**Economic and Social Council**Distr.: General
19 December 2012

Progress on the development of new global technical regulations (gtrs) and of amendments to established global technical regulations (gtrs) – Gtr No. 2 (motorcycles emissions)**Authorization to develop amendments to gtr No. 2 (motorcycles emissions)****Submitted by the representative of Japan***

III. Proposal for a supplement to gtr No. 2 (ECE/TRANS/180/Add.2/Amend.1)

Figure A13-1: Example of a gearshift sketch

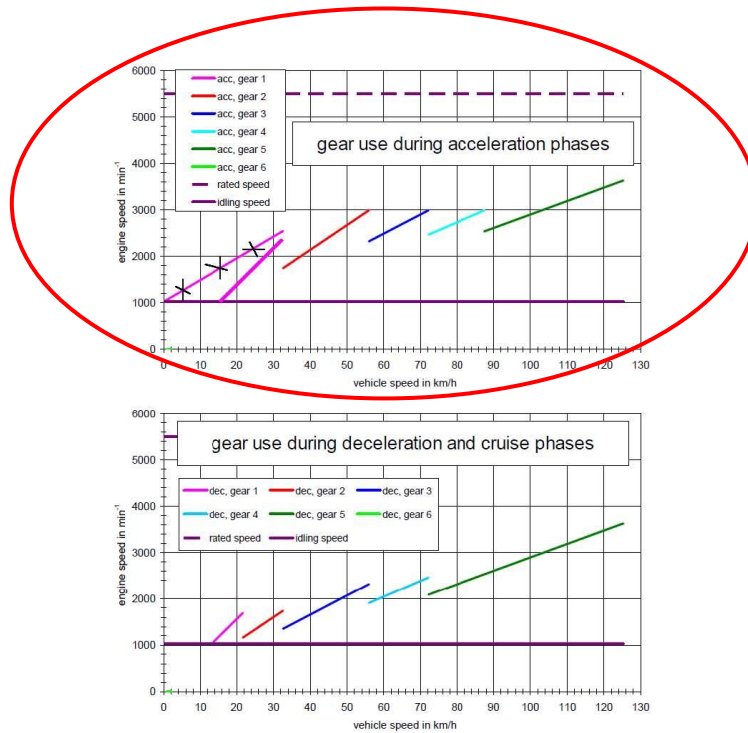
Annex 13, paragraph 1. Figure A13-1, correct the line for "acc.gear 1" in the upper figure for "gear use during acceleration phases" as reproduced below.
